Issue Date	30/08/2021	RFI No.	113
Attention	Julian Kersey	Category / topic	Cost Allocation
Urgency	High	Date required	06/08/2021
Subject	Pre-2011 Ducts

Pre-2011 ducts: In the final IM decision related to the Financial Loss Asset (FLA) we set out 'filters' that should be applied to pre-2011 assets for inclusion in the FLA. One of these was usability. The information Chorus has provided in relation to pre-2011 assets included in its initial RAB proposal does not appear to have applied any usability filter/factor to existing ducts in UFB won geographies before applying a connections-based allocator. We have information Chorus previously provided in its response to a s98 request during the UCLL/UBA FPP process (13 May 2015 cover letter and excel spreadsheet included in the response ('CONFIDENTIAL INFORMATION (CI) Copy of Response to Commerce Commission s98 request Q2 2.xls')) that indicated a number of limitations relating to the re-use of existing ducts, and that the proportion of routes available for re-use was relatively low (7.2% nationally, and up to a max of ~30-40% in the larger ESAs).

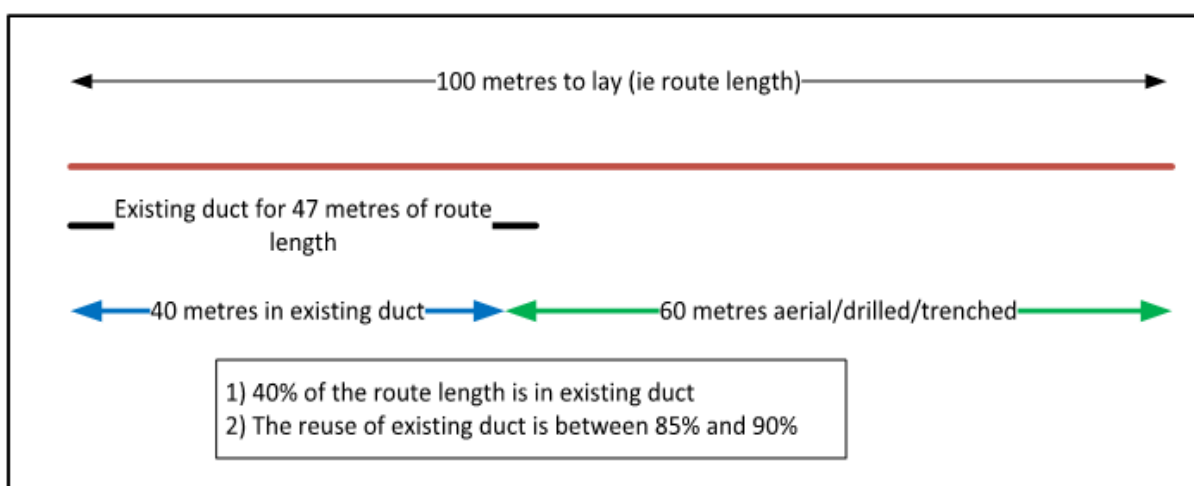
Is there any further clarification or information Chorus can provide that can help us reconcile these seemingly conflicting data sets?

- Approximately 50% of the route in UFB areas has pre-existing duct. 80% reuse of this 50% of total route would lead to 40% of the total route being made up of reused duct.
- The following diagram illustrates the reuse of existing ducts for the deployment of UFB, whereby 40% of the total route length was the target for reused duct.

- As demonstrated by para B16.1 of the section 98 response cover letter dated 13 May 2015, in fact approximately **80-90%** of the existing ducted route length in UFB1 areas was in practice reused for UFB1.
- We note that that given the timing, this data can only relate to UFB1, as UFB2/2+ agreements were only signed in 2017.
- As an example:
 - o Target route length for UFB: 100m
 - o Existing ducted route length: 47m (remainder is direct buried or uses aerial (i.e. poles))
 - o Reused ducted route length for UFB: 40m
 - o New trenching/duct for UFB: 35m
 - o Aerial deployment for UFB: 25m
- This example has been modelled on the data presented in the Scheme Booklet (13 September 2011), page 98:
